Access Compliance Report

Public Rights-of-Way

Intersection ID: 54301	Main Street: GOLF_LINKS_DR	Cross Street: PROVIDENCE_FARM_LN	Location: SE
ADA ID: 449A61EA6C83	Ramp Type: Perp	Initial Pass/Fail: Fail	Overall Compliance: No
Severity Score: 12.5			
Codes/Mitigation Info/Possible Solution		Field Measurements/Component Compliance

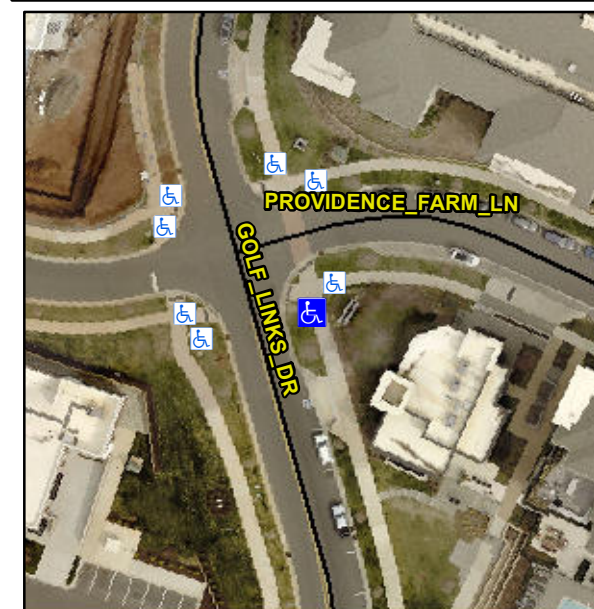
Not Found, R304.2.2

Compliance	Description	Data	Compliance	Description	Data
N/A	Ramp Length (in)	88.0	No	Ramp Slope (%)	9.0
Yes	Ramp Width (in)	89.0	Yes	Ramp XSlope (%)	1.9
N/A	Flare Type LT	N/A	N/A	Flare Type RT	N/A
N/A	Flare Slope LT (%)	N/A	N/A	Flare Slope RT (%)	N/A
N/A	Flare Traversable LT?	N/A	N/A	Flare Traversable RT?	N/A
N/A	Landing Length (in)	N/A	N/A	DWS Provided?	N/A
N/A	Landing Width (in)	N/A	N/A	DWS Contrast?	N/A
N/A	Landing Slope (%)	N/A	N/A	DWS Length (in)	N/A
N/A	Landing X Slope (%)	N/A	N/A	DWS Full Width?	N/A
N/A	Landing Curb? (Y/N)	N/A	N/A	DWS Offset (in)	N/A
N/A	Shared Landing?	N/A			
N/A	Gutter Ponding?	N/A	N/A	Gutter Slope (%)	N/A
N/A	Gutter Lip Ht (in)	N/A	N/A	Gutter X Slope (%)	N/A
N/A	Painted X Walk1?	No	N/A	Painted X Walk2?	N/A
	X Walk 1 Direction	To W		X Walk 2 Direction	N/A
N/A	X Walk 1 Width (in)	N/A	N/A	X Walk 2 Width (in)	N/A
	X Walk 1 Slope (%)	2.6		X Walk 2 Slope (%)	N/A
	X Walk 1 X Slope (%)	1.4		X Walk 2 X Slope (%)	N/A

Remove & Replace Entire Ramp.
